**Conditions for Approval of Site Plan for Subdivision**

**SITE PLAN FOR BLDG. PERMIT SITE PLAN FOR SUBDIVISION**

**UPTOWN SPECTRUM DRB SUBMITTAL**

**RESPONSE TO CONDITIONS**

**LANDSCAPE PLAN**

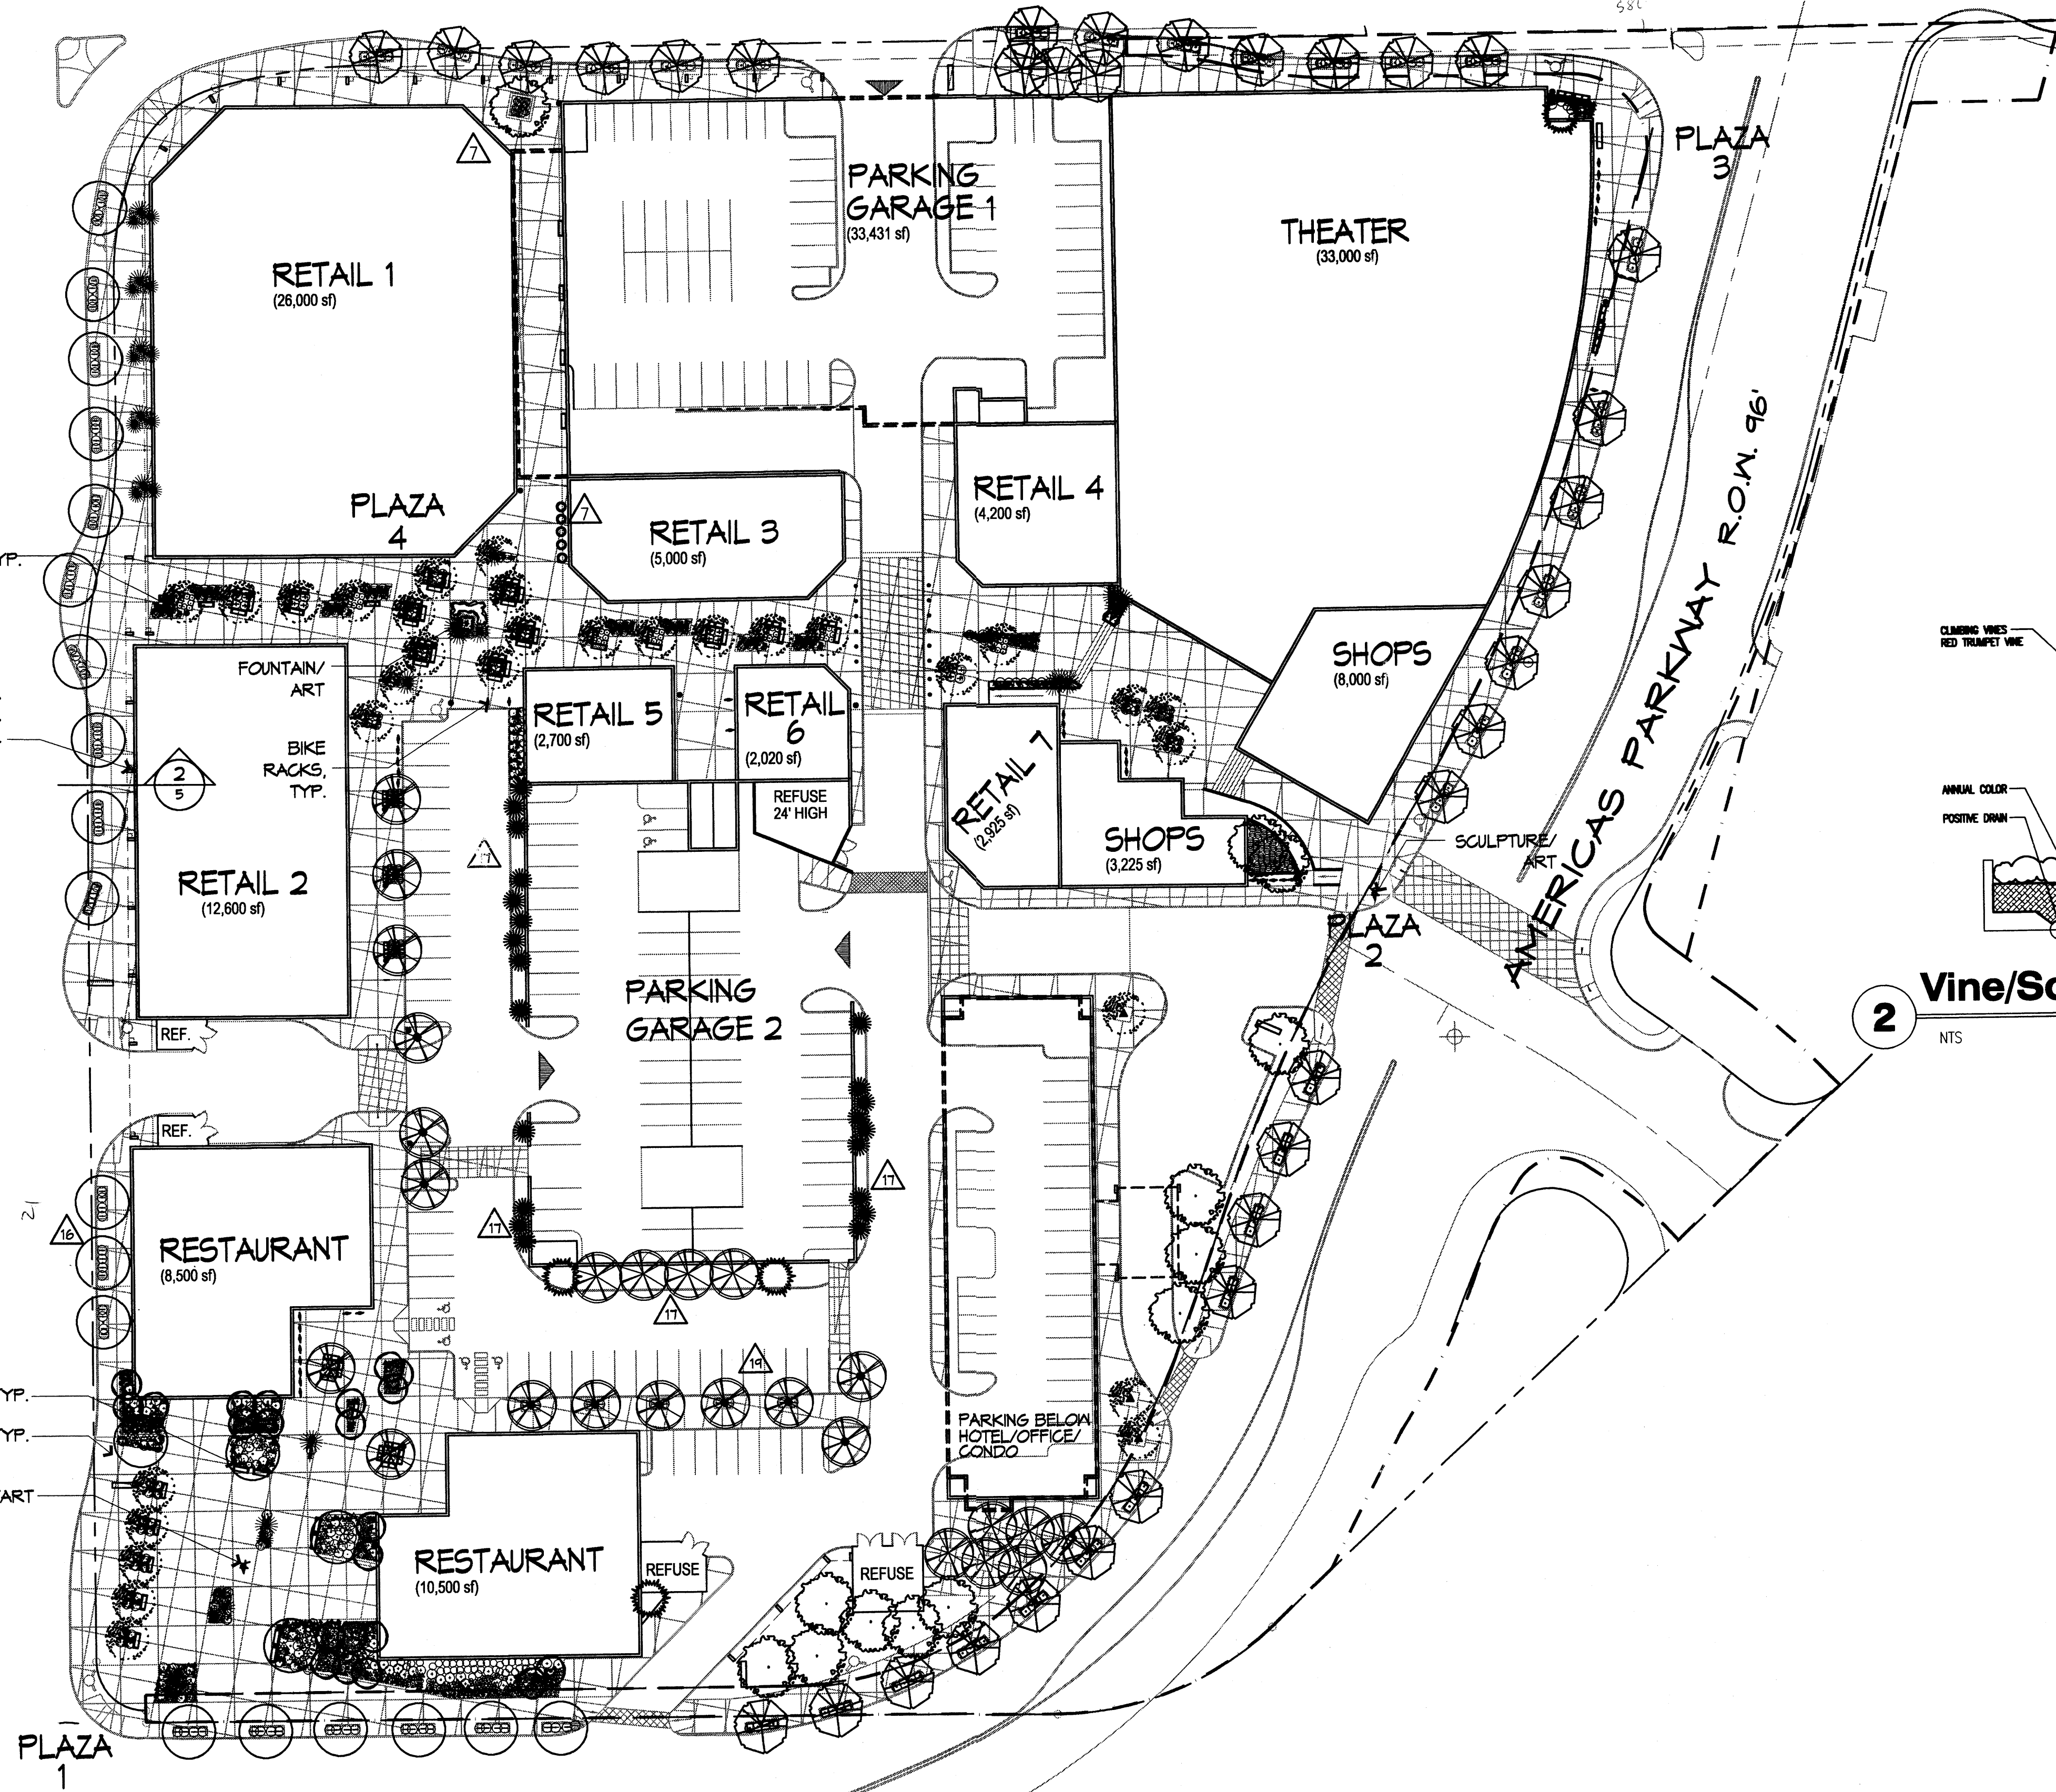
- The applicant shall submit for DRB review a complete landscape plan, including all required vegetation elements, specifying such specific landscape details as bench placement, planter areas, tree planting hole and grade details, drainage, and irrigation. The applicant shall also provide landscape plans for all plaza areas, drawn in detail at a maximum scale of 1"=10'. The plan should also locate and identify lighting, signage, public art and other elements not well illustrated in the submitted plans.

- Street trees shall be added at 30 feet on center on the Westside of the restaurant building along Louisiana.
- Delete the walkways shown on the east, west and south side of the parking garage number 2, convert it to landscaping.

- Improve pedestrian connections from garage number 2 to the pedestrian ways to the east, west, and south of the site.
- Widen the sidewalk directly to the east of the south restaurant; the sidewalk runs in an east/west direction. Shade trees shall be added at 25 feet on center along the pedestrian way.

- △ The Landscape Plan consists of three sheets - one 40-scale site plan and two sheets of 10-scale Plaza enlargement plans. Locations for site furnishings, including benches, waste receptacles, portable planters, tree guards and art, are illustrated on the landscape plans. Plant materials are illustrated on the plans and keyed to plant schedules located on each Landscape sheet.

- △ Planting and irrigation installation details shall be per City of Albuquerque standards.
- △ Additional landscaping has been added at several locations around the site. Portable plantings have been added as an entrance to the north-south pedestrian walkway east of Retail 1. A fountain is now illustrated in the center of the pedestrian mall between retail buildings 1, 2, 3 and 5.

- △ Street trees at 30' o.c. have been added to the west side of the restaurant building located on Louisiana.
- △ The walkways on the east, south and west of Garage 2 have been converted to landscaping.

- △ The east-west sidewalk on the north side of the restaurant has been widened. At grade planters and shade trees at approximately 25 feet o.c. have also been added to the plan.

1 Housing over Garage 2 -Site Plan  
Scale: 1/16" = 1'-0"

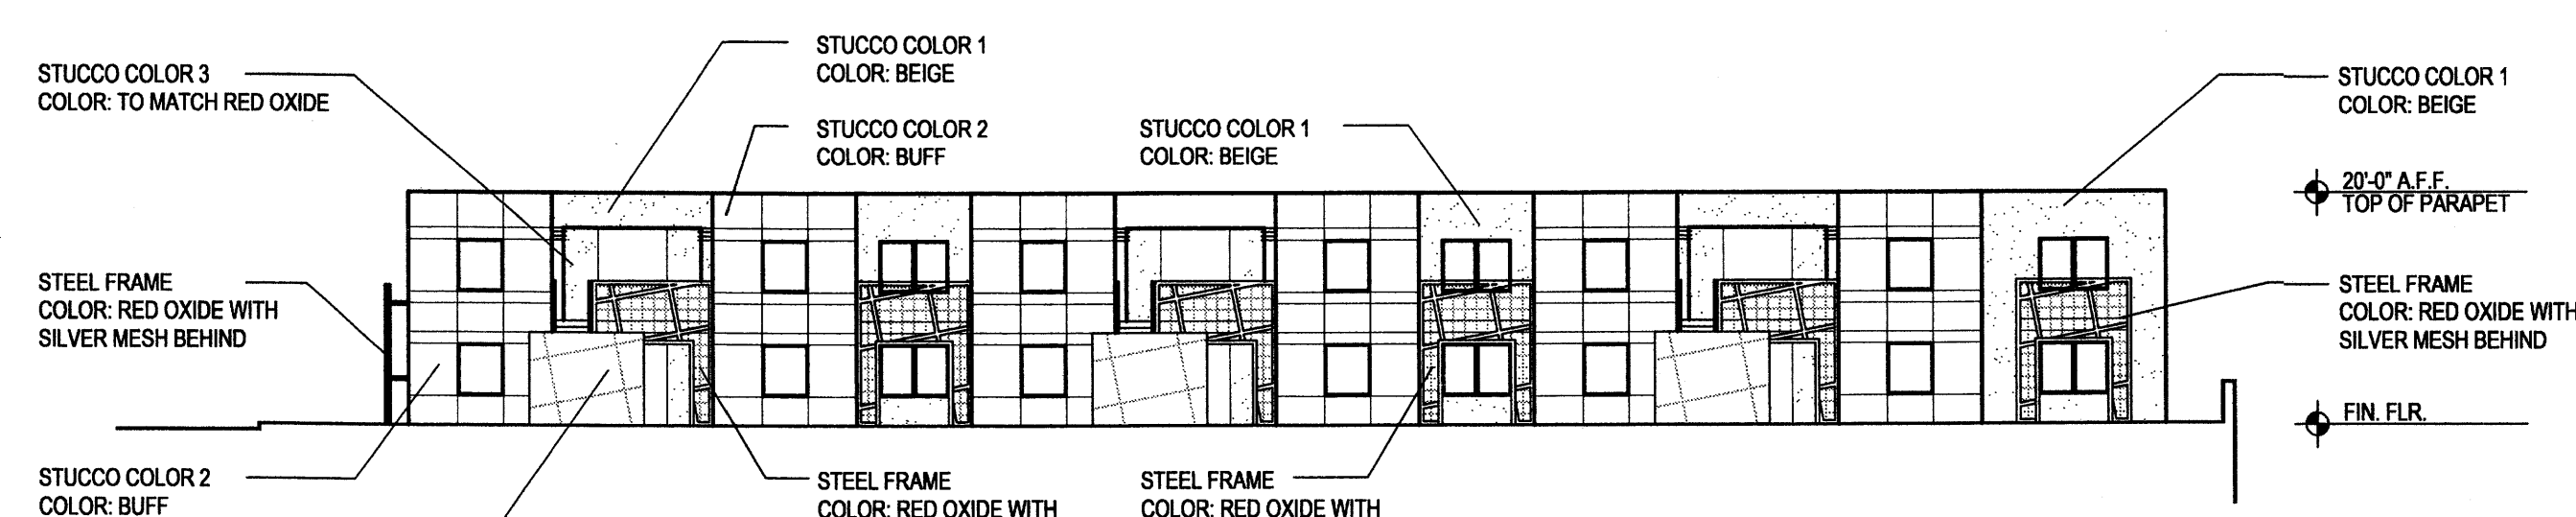
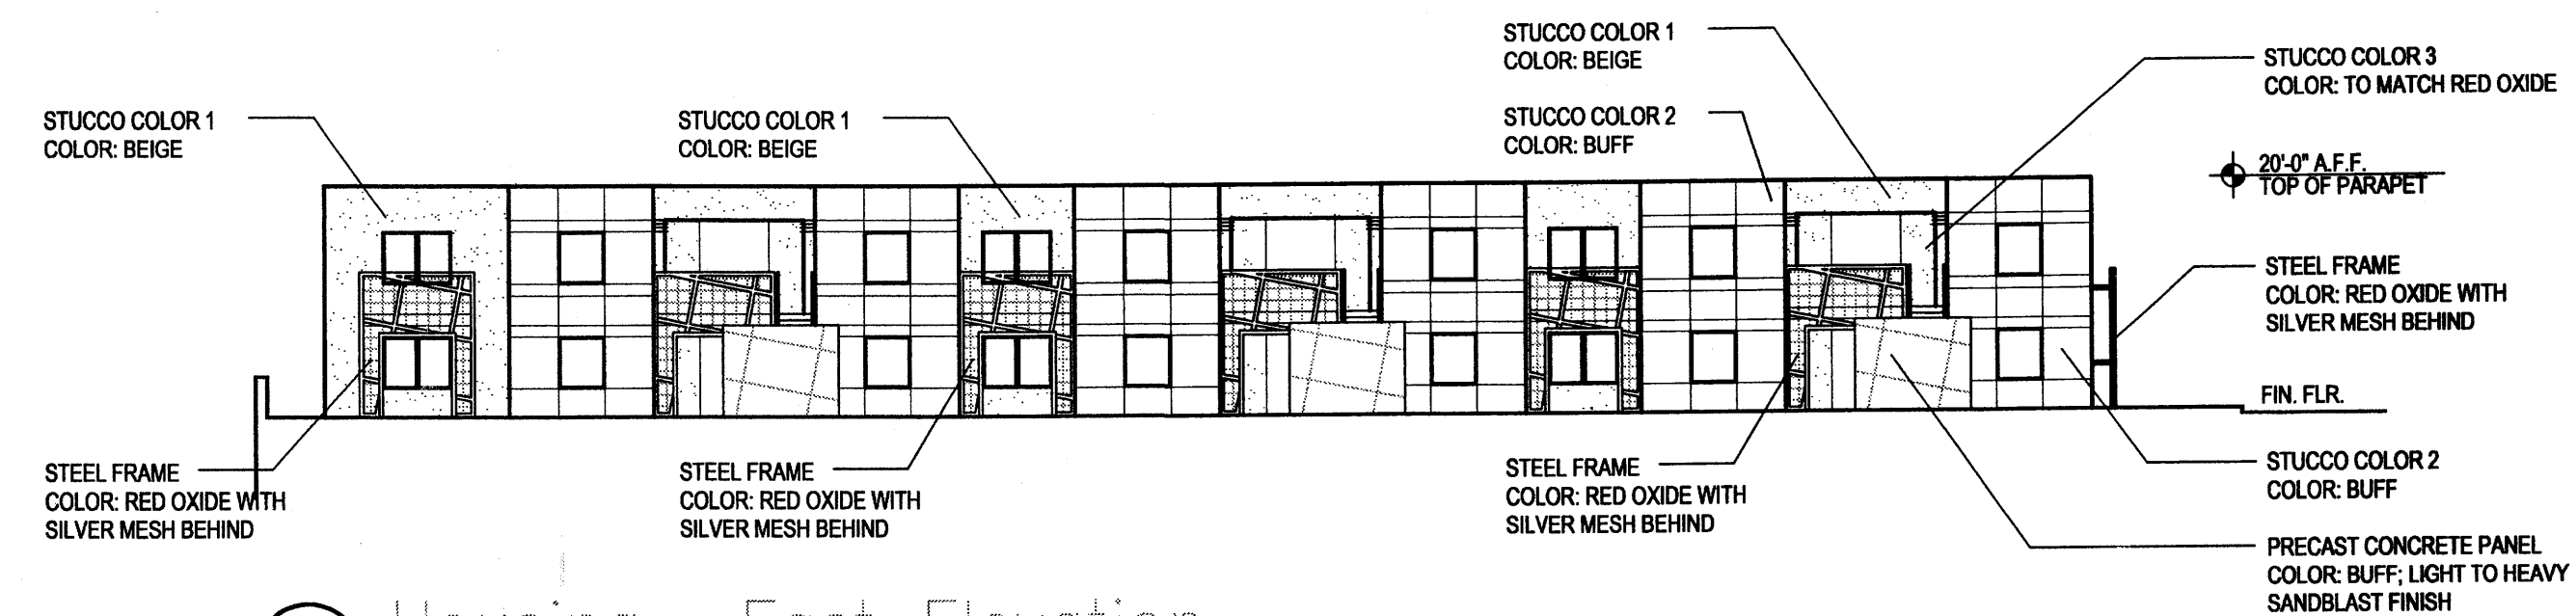
- Each housing unit shall have a minimum of 80 square feet of open space adjacent to the unit in form of decks, terraces, or patios and a maximum of 1 parking space per unit. The revised site plan shall be submitted to the EPC site plan review committee for final approval prior to DRB submittal.

80 SF OUTSIDE  
DECK/PATIO (1 PER UNIT)
